Staff Report & Recommendation

Historic Preservation Board

SUBJECT: HPB24-0632, **1730 Jefferson Avenue.**

The applicant has submitted plans entitled "Hill & Gamboa Family Residence", as prepared by DGO Architecture, dated June 17, 2025.

*Currently proposed rendering*

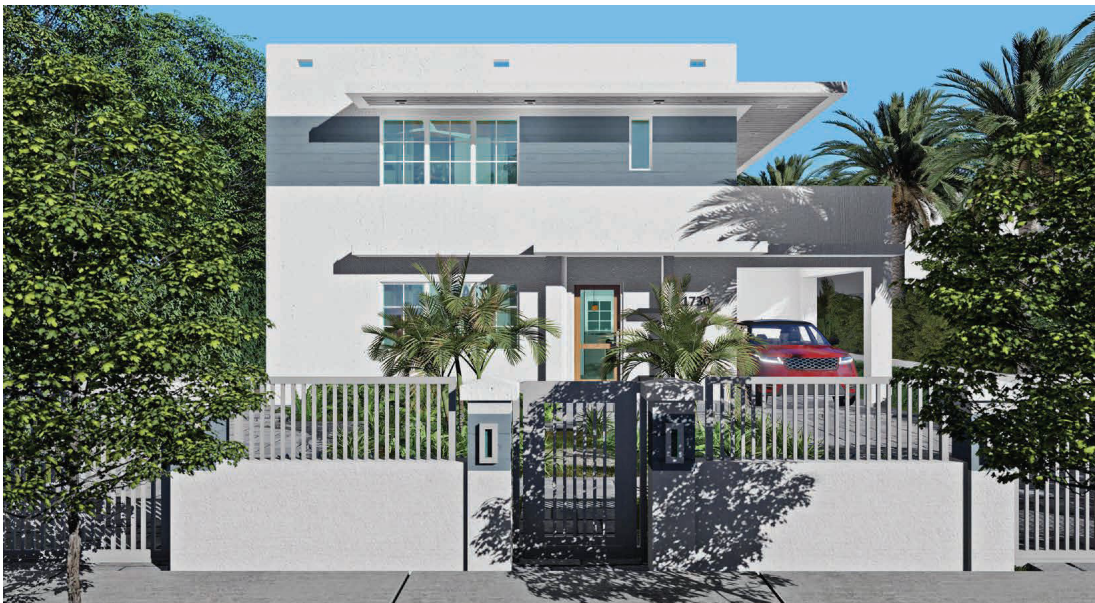
On April 22, 2025, the Historic Preservation Board reviewed and continued the subject application to a date certain of June 17, 2025. Since the April hearing, the applicant has submitted revised plans including the following modifications:

- The front façade of the home has been further refined including:
  - The retention of the racing stripes at the second level.
  - The introduction of historically accurate window muntins.
  - The proposed eyebrow/overhangs have been lowered closer to the top of the existing openings.

- The trim color has been lightened.
- The design of the front wall has been revised to include vertical pickets.
- The rear accessory building rooftop addition has been revised to comply with the required 15'-0" rear accessory building setback resulting in a reduction of the unit size variance request and the elimination of the rear accessory building setback, rear yard open space and rear yard lot coverage variances.

Staff remains supportive of the proposed additions which will not be visible from Jefferson Avenue. Further, staff believes that the modifications to the front façade of the home, as outlined above, are more consistent with the original design. Staff continues to be concerned, however, with the proposed new overhangs which are disconnected from the window and door openings and are not consistent with the original design. As such, staff recommends that the primary façade be retained and restored consistent with available historic documentation, inclusive of the retention and restoration of the existing eyebrows, or their reconstruction.

1. Revised elevation, site plan and floor plan drawings shall be submitted, and at a minimum, such drawings shall incorporate the following:
    - a. The primary (east) façade of the home shall be restored to the greatest extent possible, consistent with available historical documentation, in a manner to be reviewed and approved by staff consistent with the Certificate of Appropriateness Criteria and/or the directions from the Board.
